RE: Response to Comments

The Aurora Highlands North – Area C – Site Plan – First Review

Application Number: DA-2062-44

Case Numbers: 2023-4023-00

TITLE: AREA C - COMPARISON EXHIBIT

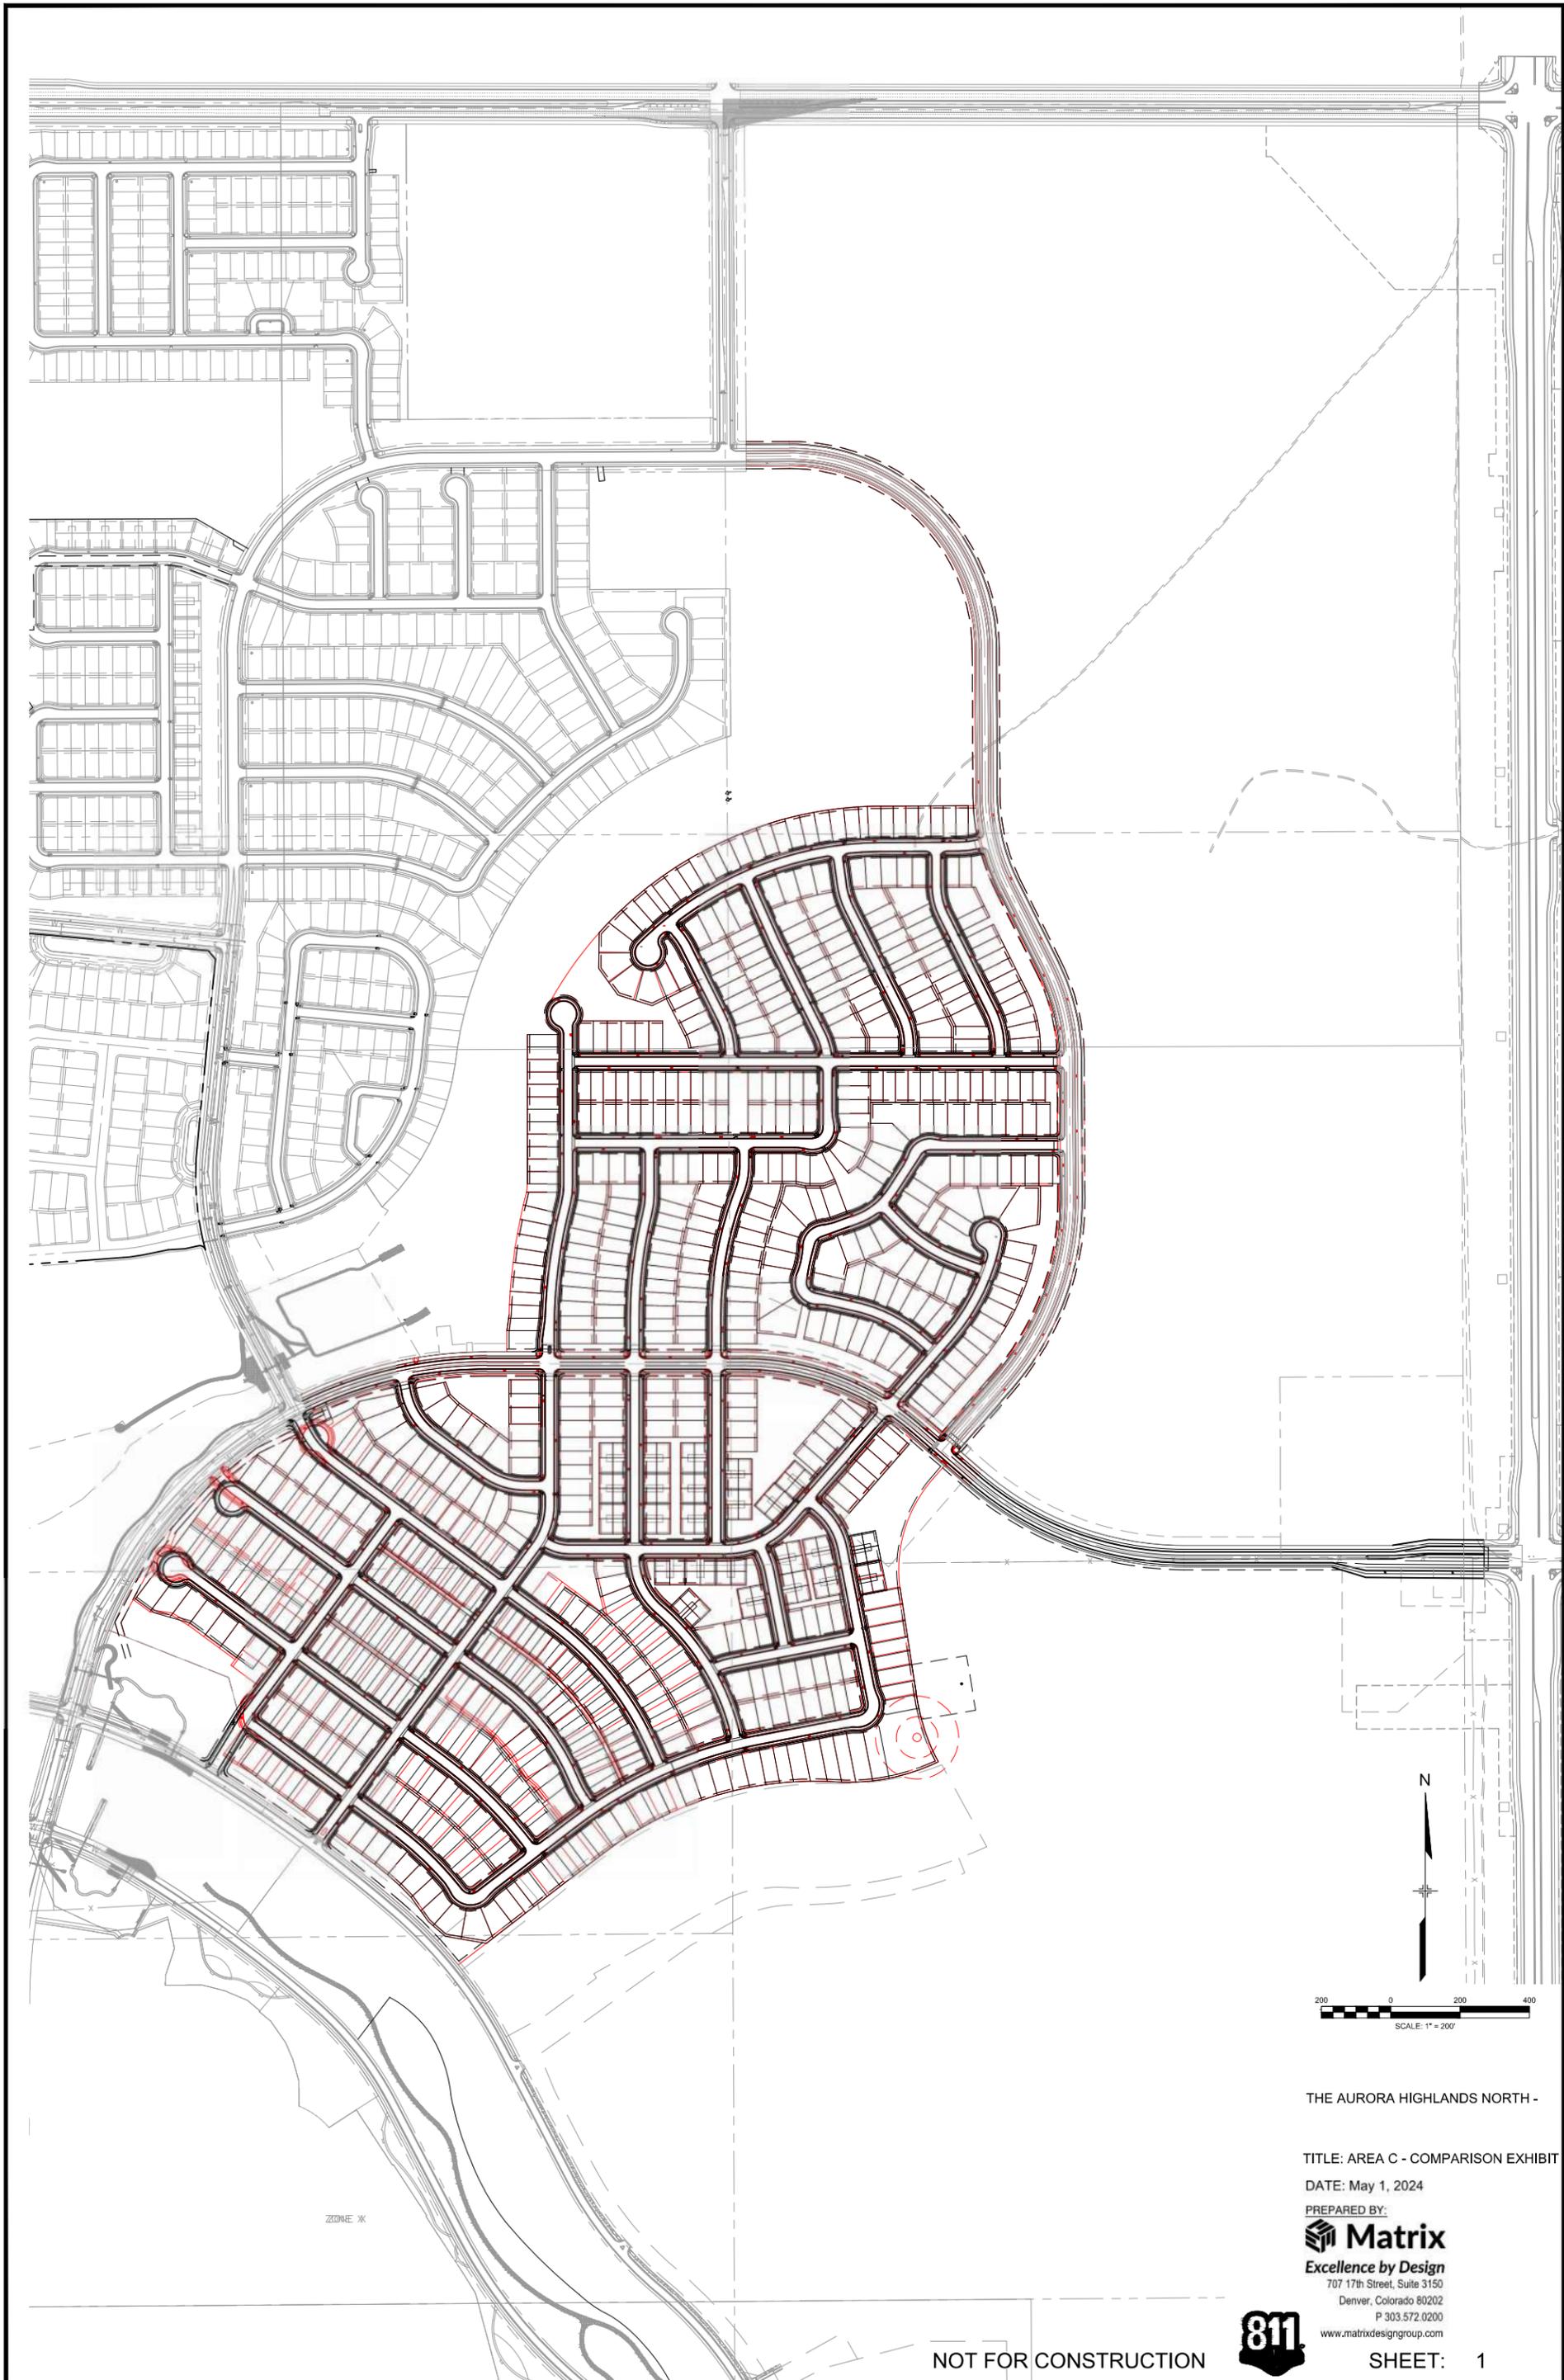
Please note that the Lot Tracking chart has been revised to include Site Plans 17 & 21, as well as revisions to lot type and count in PA 46.1 (Area C), resulting in a revised Lot Total. Please see the exhibit at the end of this letter.
